## SB 98-10-1

TO: RV-6A Builders and Operators

APPLICABILITY: All RV-6A aircraft using nose gear leg **U-603** (nose gear legs shipped with finish kits prior to 1999).

FIGURE 1

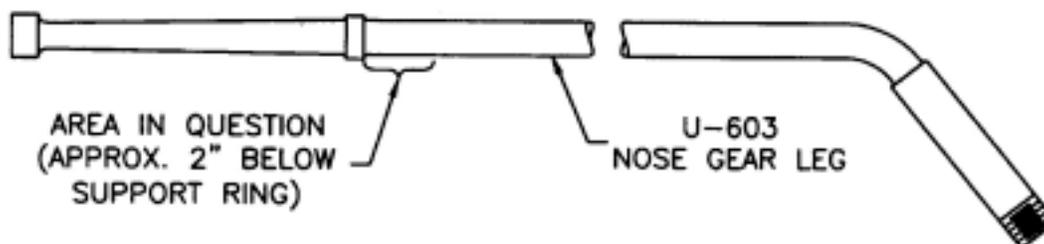
3. Polish the full circumference of the area in question (see figure 1) to remove any superficial surface blemishes. Use strips of progressively finer grit sandpaper or emery cloth. The abrasive strips should be worked over the area in question using a back-and-forth motion much like when using a soft rag to polish a shoe.

4. Clean any sanding residue from the area in question using a solvent dampened cloth.
5. Inspect for small cracks that could propagate and eventually cause failure. A visual inspection using a magnifying glass is considered minimum with a dye penetrant inspection or magnetic particle inspection recommended.

6. Nose gear legs without cracks may be returned to service. The nose gear leg inspection procedure must be repeated at each annual inspection or 100 flight hours, whichever occurs first.

7. Nose gear legs having cracks must be replaced with a current production nose gear leg before further flight.
